INNER WEST COUNCIL

DEVELOPMENT ASSESSMENT REPORT

Application No.	DA201700214.01
Address	15 William Street, Marrickville
Proposal	Review request under Section 82A of the Environmental Planning and Assessment Act to review Determination No. 201700214, dated 17 July 2017, being a refusal of a development application to demolish part of the premises and carry out alterations and additions to a dwelling house including the construction of vehicular crossing and garage
Date of Lodgement	23 October 2017
Applicant	David D'ettore
Owner	Pasquale Barbalace
Number of Submissions	18
Value of works	\$99,000
Reason for determination at Planning Panel	A request made under Section 82A of the <i>Environmental Planning & Assessment Act 1979</i> and there is no substantial change in recommendation on the matters subject of the Review.
Main Issues	<ul style="list-style-type: none"> • Poor architectural outcome for the street • Adverse impacts to the architectural integrity of the period dwelling house • Adverse impacts to on-street car parking • Removal of a street tree

Attachment C - Plans of proposed development

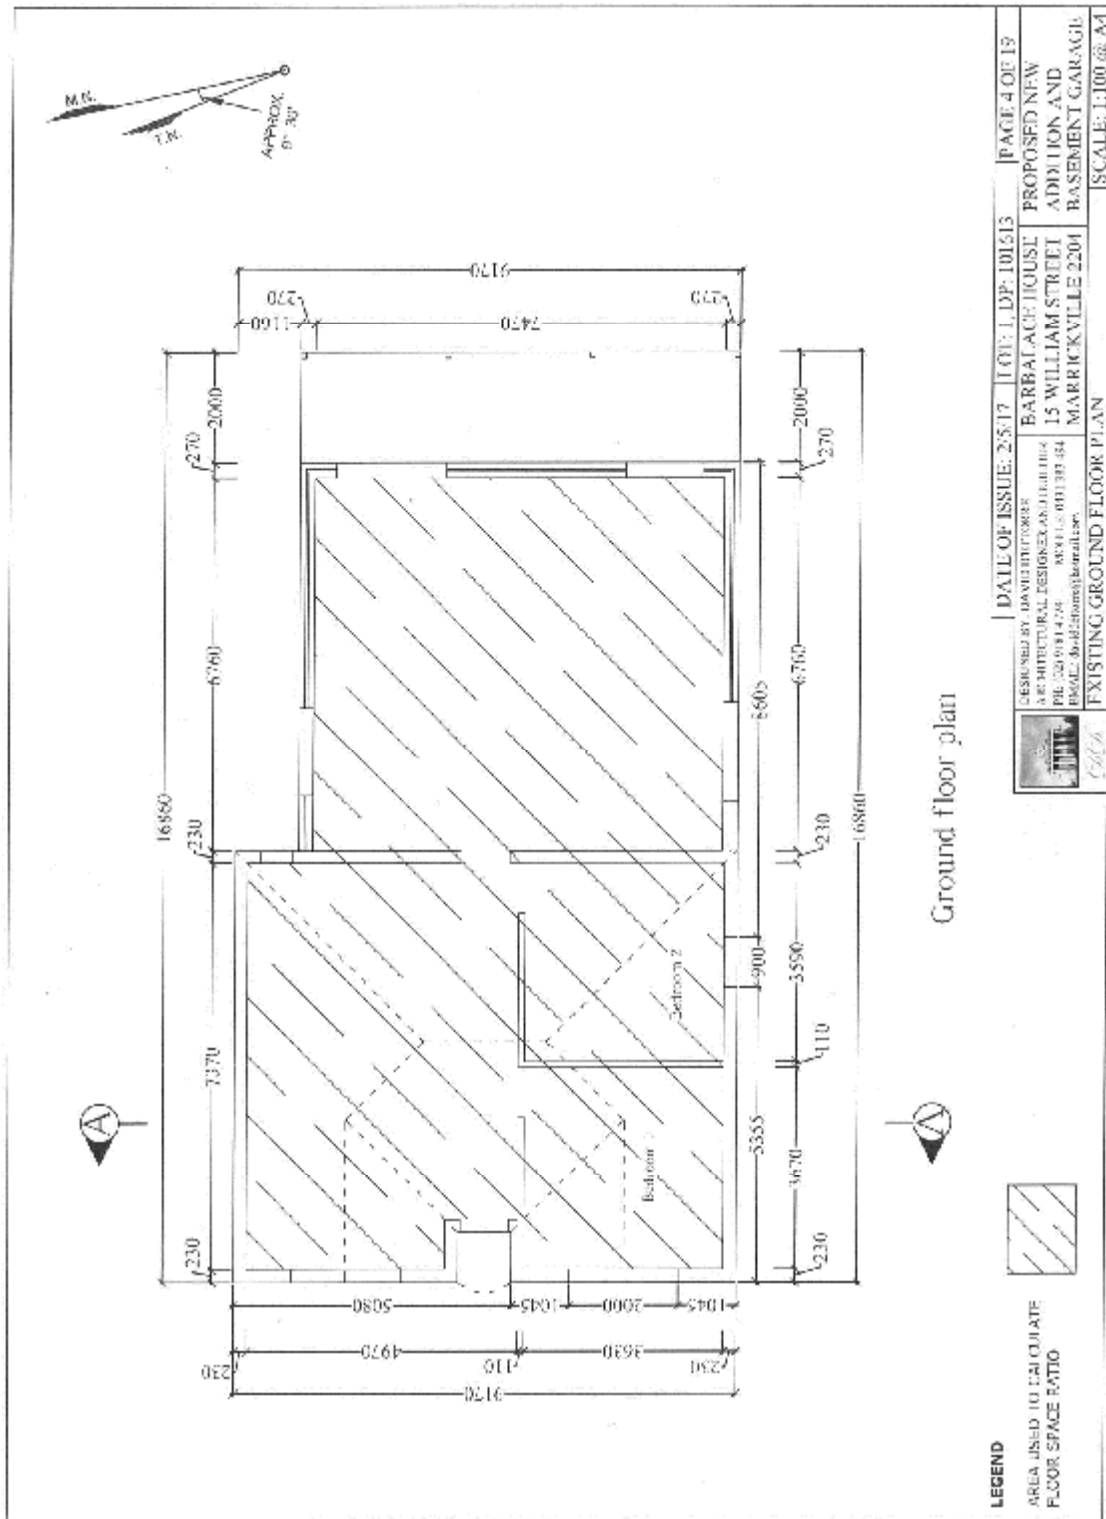
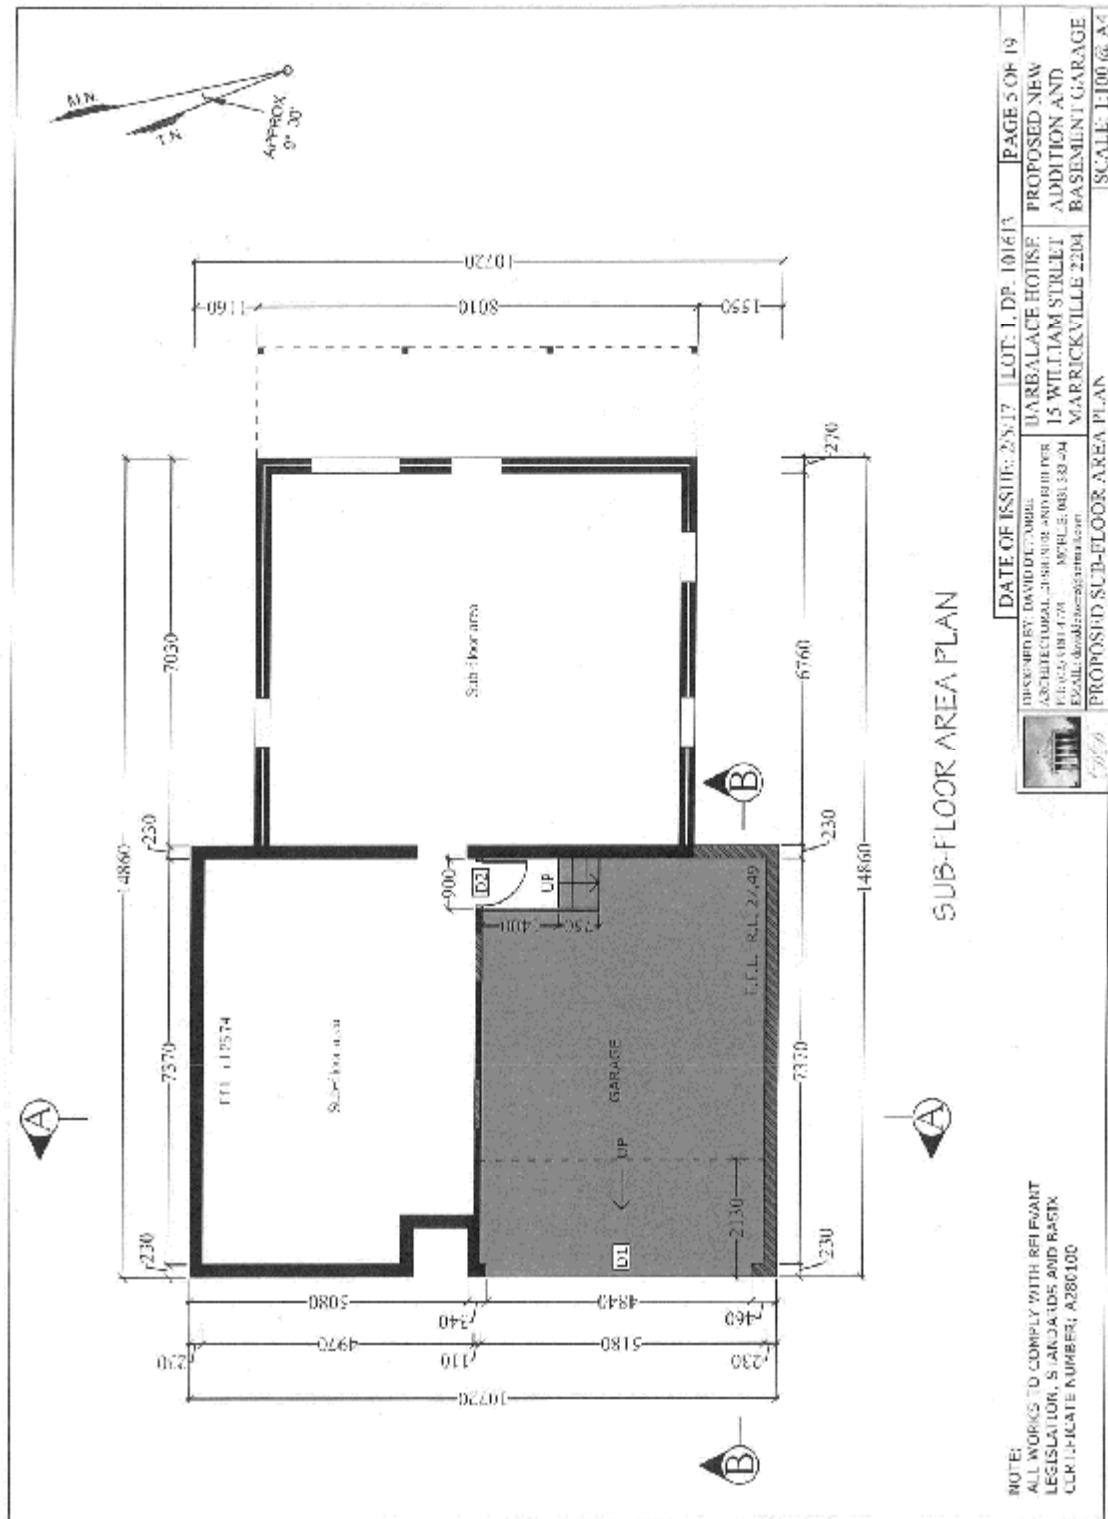
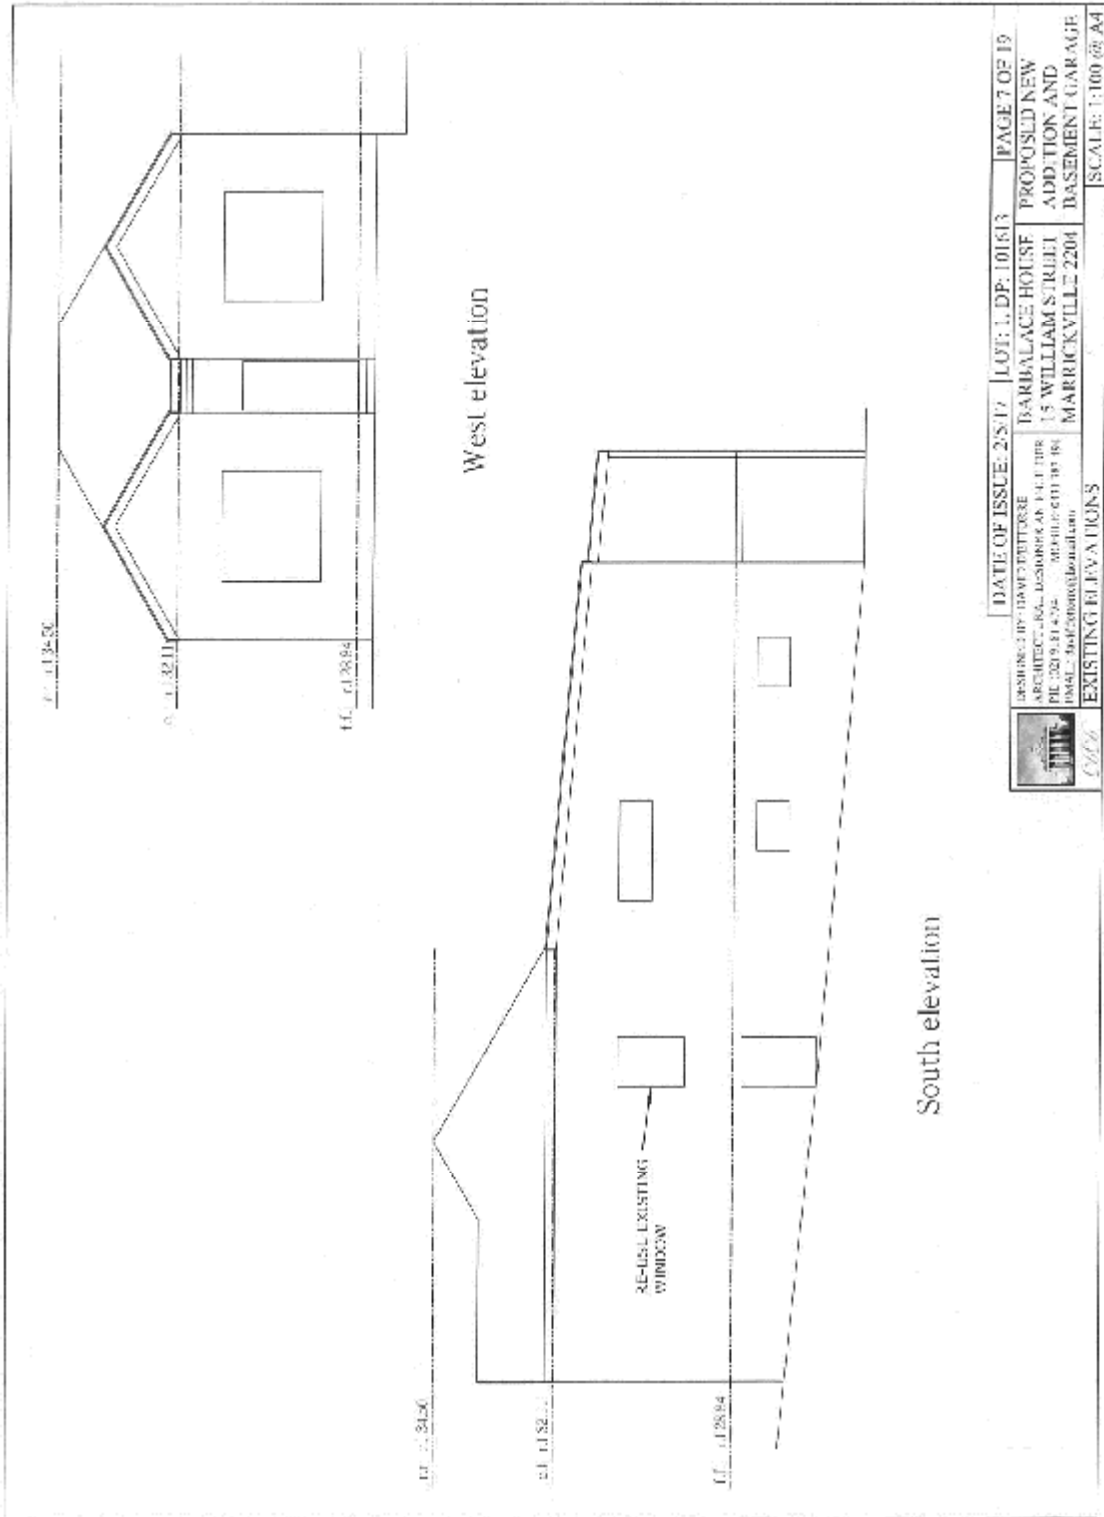
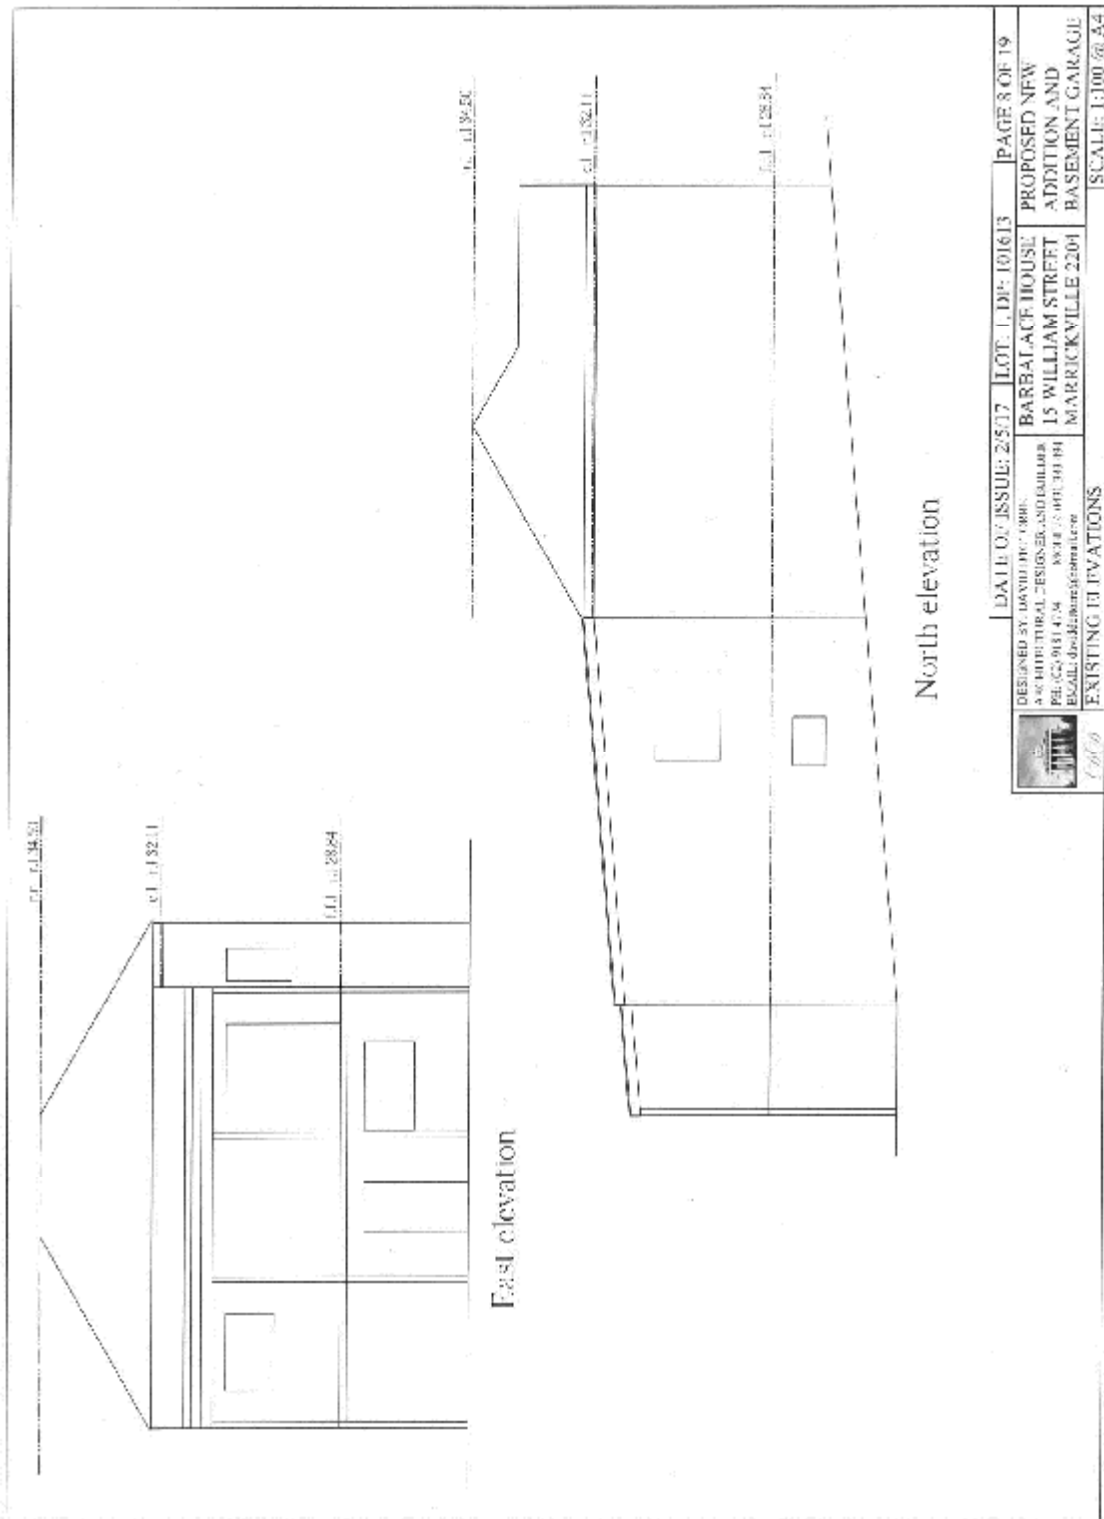
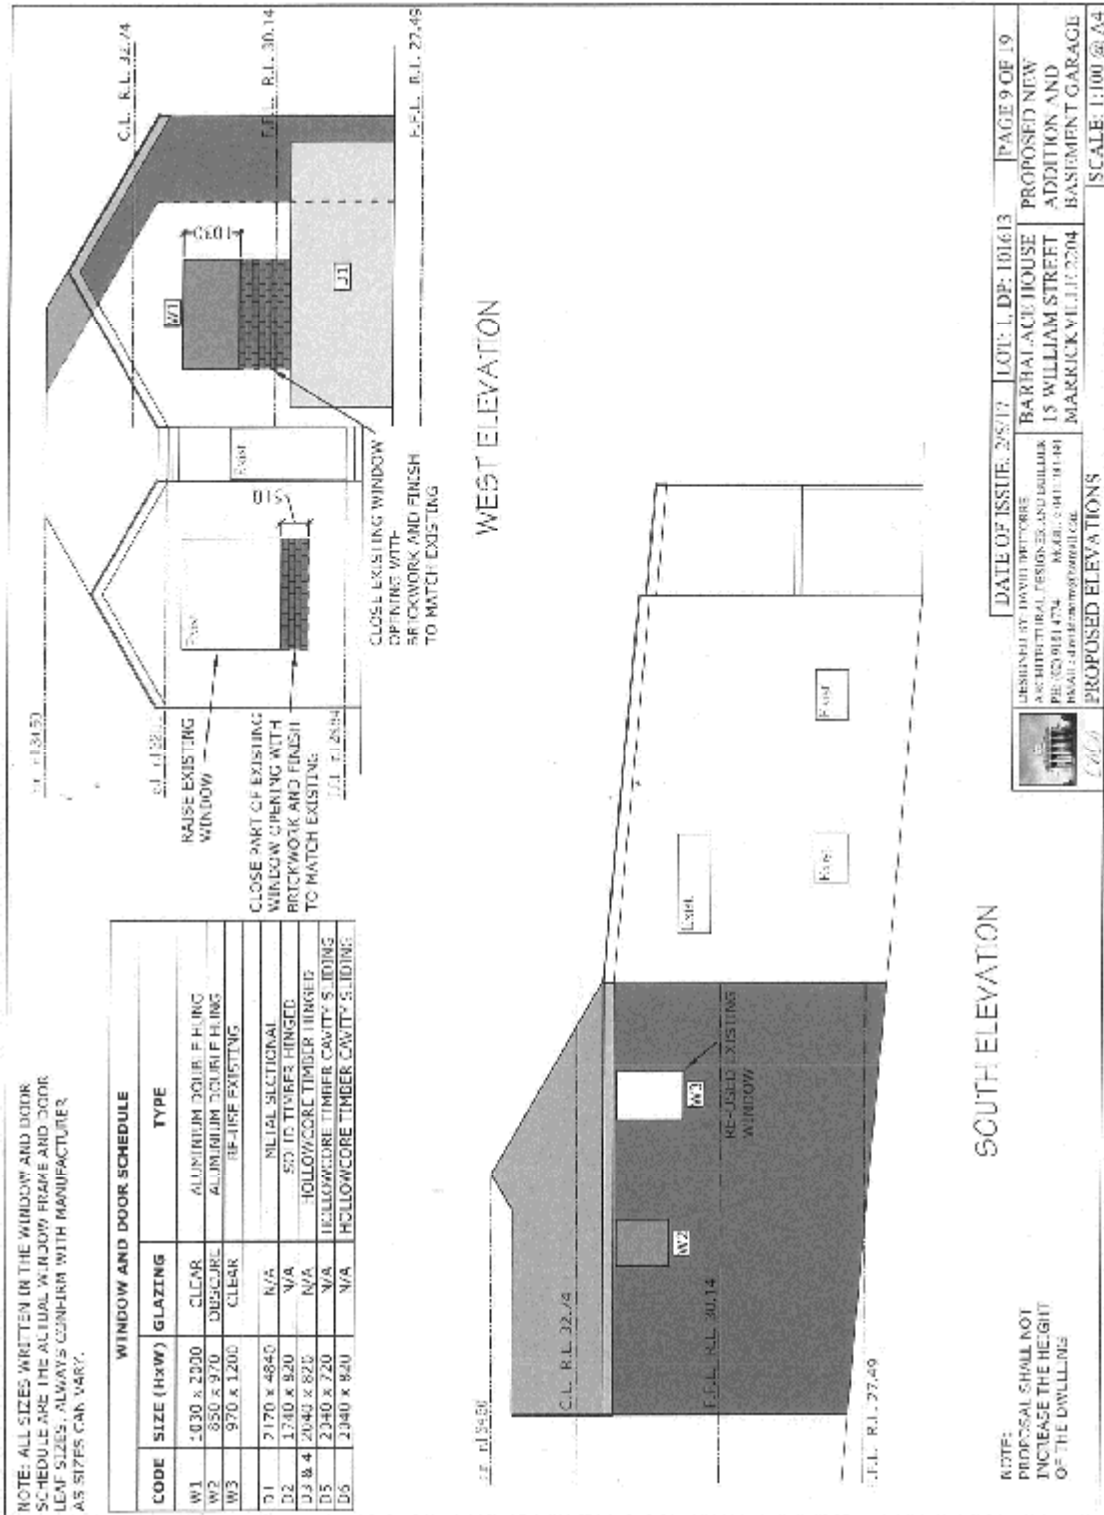
The proposal seeks to partially excavate and demolish the front façade of the dwelling house to accommodate a garage within an existing subfloor basement, create a side extension to enlarge bedrooms and provide an ensuite, relocate windows on the side (southern) elevation and brick up front windows. The above works will diminish the architectural presentation of the period dwelling façade by altering the original massing and architectural features of the dwelling house, reducing the size of window openings and creating structural elements (such as the garage door) that are not original to; and will not complement the main body of the dwelling façade when viewed from the street.

The above modifications will be obvious and noticeable and will create a poor design outcome and precedent for the street. The proposed sub-basement double garage will be a visually detractive feature for the locality and is inappropriate for the context of the street, which contains no double garages.

The development increases the overall massing of the roof to accommodate a side extension to the dwelling house to accommodate larger bedrooms and an ensuite. It appears that the development will cause additional shadow impacts to the northern (side) facing windows and private open spaces of 11 William Street and 18 Bright Street between 9.00am and 3.00pm on 21 June. However, the application was not accompanied by hourly and/or elevational shadow diagrams in the prescribed period to enable a complete and proper assessment of the shadow impacts caused by the proposed development.

The proposed development is considered to create a poor urban design outcome for the street in that diminishes the architectural presentation of the existing period building by altering the original massing and façade of the dwelling house, reducing the size of window openings and creating structural elements that are not original to; and will not complement the main body of the dwelling façade when viewed from the street.

The development extends the southern end of the dwelling house to accommodate larger bedrooms and an ensuite which will be highly visible to the street, thereby creating additional visual bulk to the front façade. This results in an inappropriate distortion to the original form, architectural expression and massing of the period dwelling house.

The application proposes to increase the existing single-width driveway to 6.2 metres which will require the removal of a Bottlebrush street tree fronting the site.

- The proposal will result in the loss of 1 "on street" car parking space;
- The minimum headroom of 2.2m as required by AS2890.1:2004 has not been achieved;
- The cross section provided (Page 13 of 19) has insufficient detail to assess if a B85 vehicle will scrape the footpath when accessing the site. The vehicular crossing is required to satisfy the ground clearance template for a B85 vehicle (Figure C1-Australian Standard AS2890.1-2004). A cross section through both sides of the driveway and adjacent footpath (1 in 20 scale) is required for review and has not been provided; and
- The proposed vehicular crossing will result in the loss of a street tree.

Issue: The plans are inaccurate; with some discrepancies on the plans including an incorrect portrayal of 'proposed' works which are already completed on the dwelling house, such as a 'new' window on the south elevation, and incorrect floor levels.

Council's Tree Management Officer has recommended that the existing driveway be maintained at its existing width and the street tree retained.
